Nortronics
COMPANY, INC.
 8101 TENTH AVENUE NORTH
 MINNEAPOLIS, MINNESOTA 55427

TECHNICAL DATA BULLETIN

ATC & COLLINS CARTRIDGE RECORDERS

FIG. 2. CUE CHANNEL COUPLING

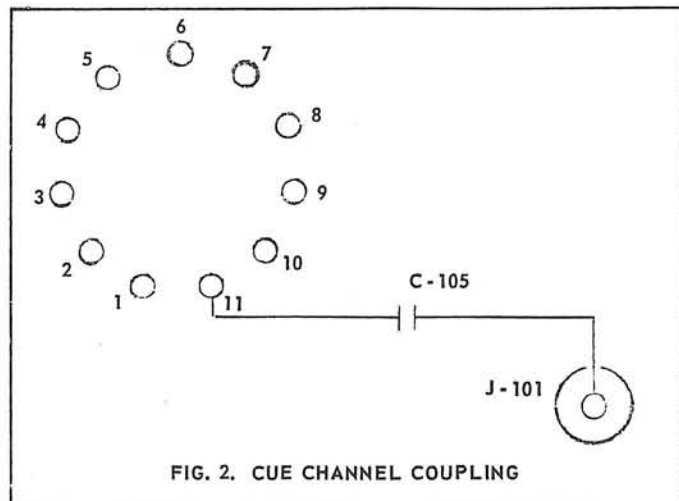
2. **A-150, A-190, P-190 cue channel triggering.** (See Fig. 2) Additional circuit modification is necessary with these amplifiers, if the cue channel does not trigger with the NORTRONICS #3000, 3001, 3200, or 3201 head.

When using the 800 mhy head (#3000 or 3200) replace the cue head coupling capacitor (C-105, 0.5 mfd) with a 0.03 mfd capacitor. With the 400 mhy head (#3001 or 3201) replace C-105 with a 0.05 mfd capacitor. The capacitor goes between the cue head jack (J-101) and pin #11 of S-101.

The cue head is connected through C-105 to the cathode of V-301A. V-301A serves as a two stage preamplifier on playback, with the grid of V-301A grounded, and the signal from the cue head fed to the cathode. By changing C-105 to a value which resonates with the head at the 1000 cps cue tone, the overall sensitivity of the head is greatly improved, because the low impedance cathode is being driven with a series resonant circuit.

FIG. 1. COLLINS/ATC A-190 & A-150

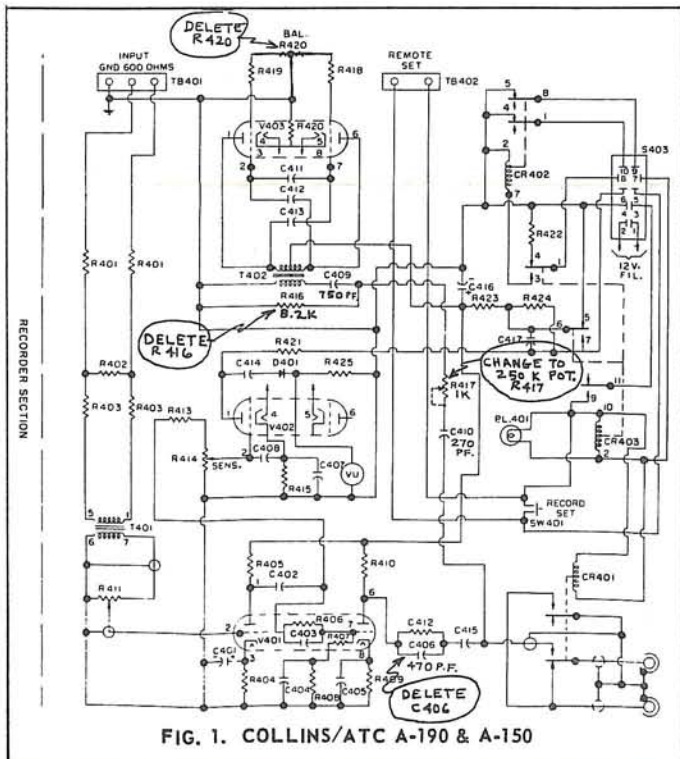
1. **A-190 and A-150 recording amplifiers.** (See Fig. 1) This type is recognizable by the push-pull bias oscillator circuit. Perform the following steps:

(a) Incorporate adjustable bias by replacing the fixed 1K resistor, R417, with a 250K potentiometer (preferably with linear taper). It may be mounted on the chassis of the recording amplifier in place of the oscillator balance control, R420, which is completely unnecessary. This will save drilling a hole. Connect the clockwise lug of the new control to C409 so that clockwise rotation of the shaft will increase the bias current. Connect the 270 pf. C410 to the wiper. Ground the grid resistors R418 and R419.

(b) Increase the bias voltage by deleting the 8.2K load resistor, R416.

(c) Reduce the high-frequency pre-emphasis on recording by deleting the 470 pf. capacitor, C406, which shunts R412. The original circuit boosts the 10kc. recording current by as much as 17 db. over the 1 kc. current, while the laminated heads only require about 10 kc. of boost for correct frequency response. If the ability to adjust the high-frequency record pre-emphasis is desired, then the 25 pf. C403 may be replaced with an adjustable mica trimmer capacitor of around 5-80 pf.
